## FL - 101 TRANSMITTER

### INSTALLATION OF RF PROCESSOR

The following installation procedure is applicable to the FL-101 transmitters bearing serial numbers 308001 and up only.

Fig. 1

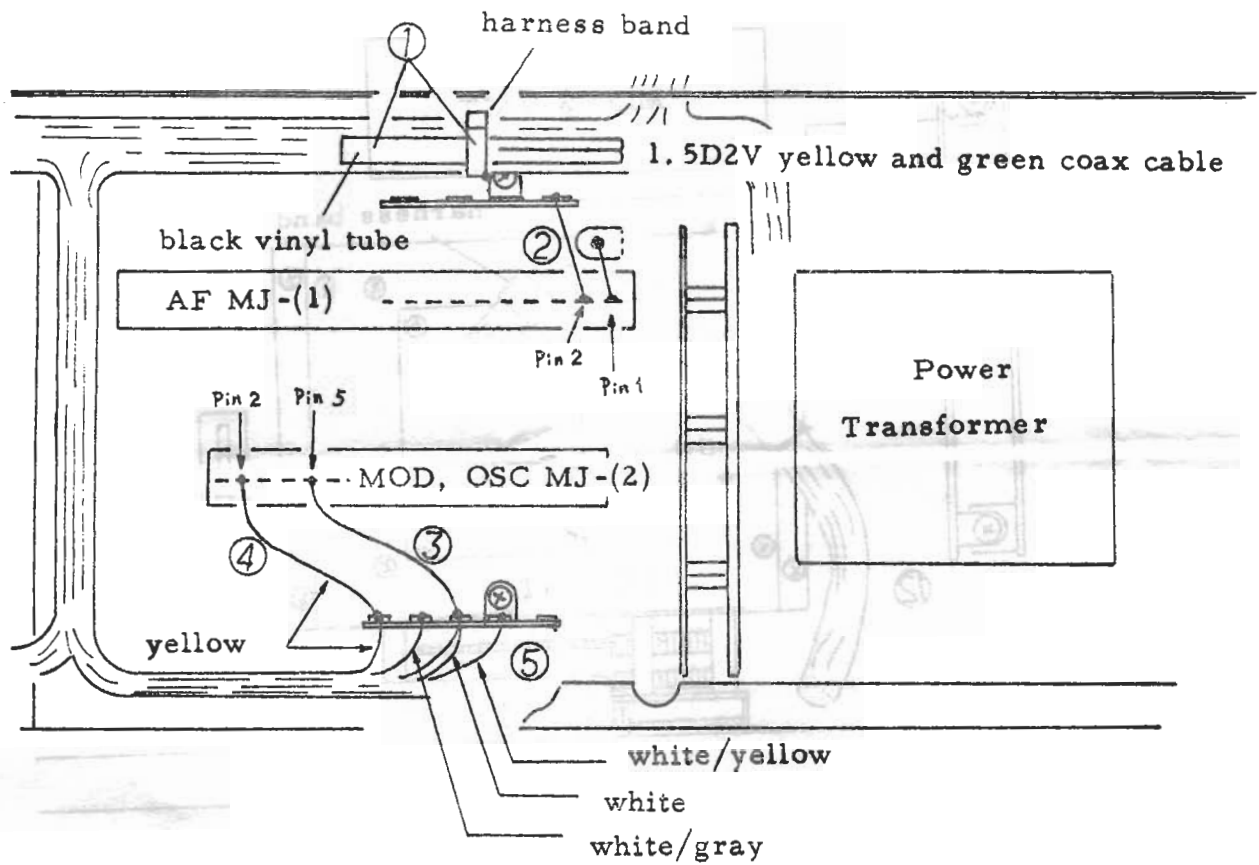
- (a) Locate black vinyl tube and cut a harness band as illustrated by (1) in Fig. 1 and remove the black vinyl tube from the yellow and green colored coax cable. As the coax cables are longer than necessary, cut a 50 mm piece from the end.

Fig. 2

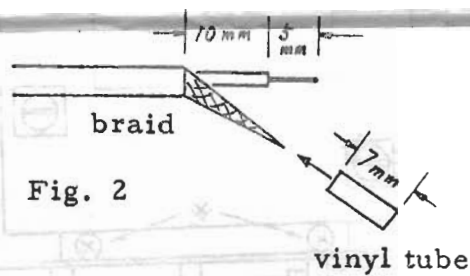
- (b) Prepare the ends of the coax cables as illustrated in Fig. 2. Remove a wire (2) between pin 2 of MJ-1 and soldering post. Locate white wire (3) between pin 5 of MJ-2 and soldering post and disconnect wire from the soldering post. Remove yellow wire (4) from pin 2 of MJ-2 and the soldering post. Disconnect white/yellow wire (5) from the soldering post.

Fig. 3

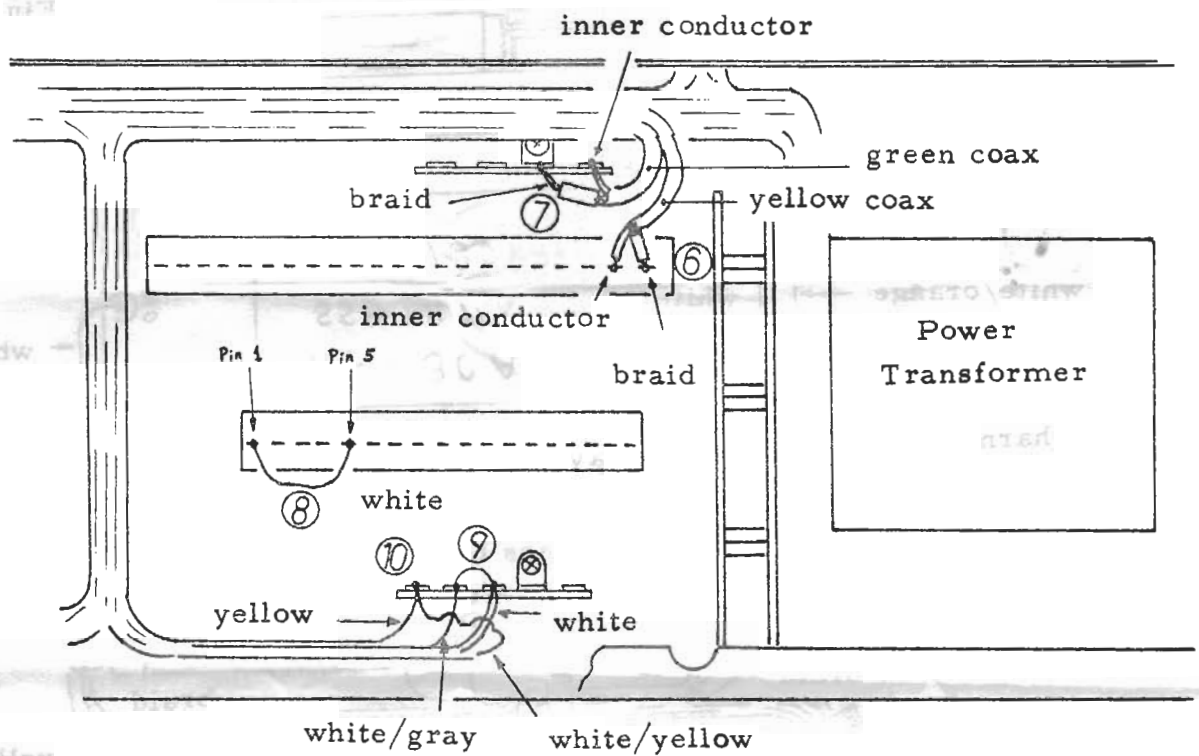
- (c) Solder the yellow coax cable (6) prepared in Step (b) to MJ-1, inner conductor to pin 2 and outer braid to pin 1. Solder the green coax cable (7) to the soldering post and outer braid to ground as illustrated in Fig. 3.
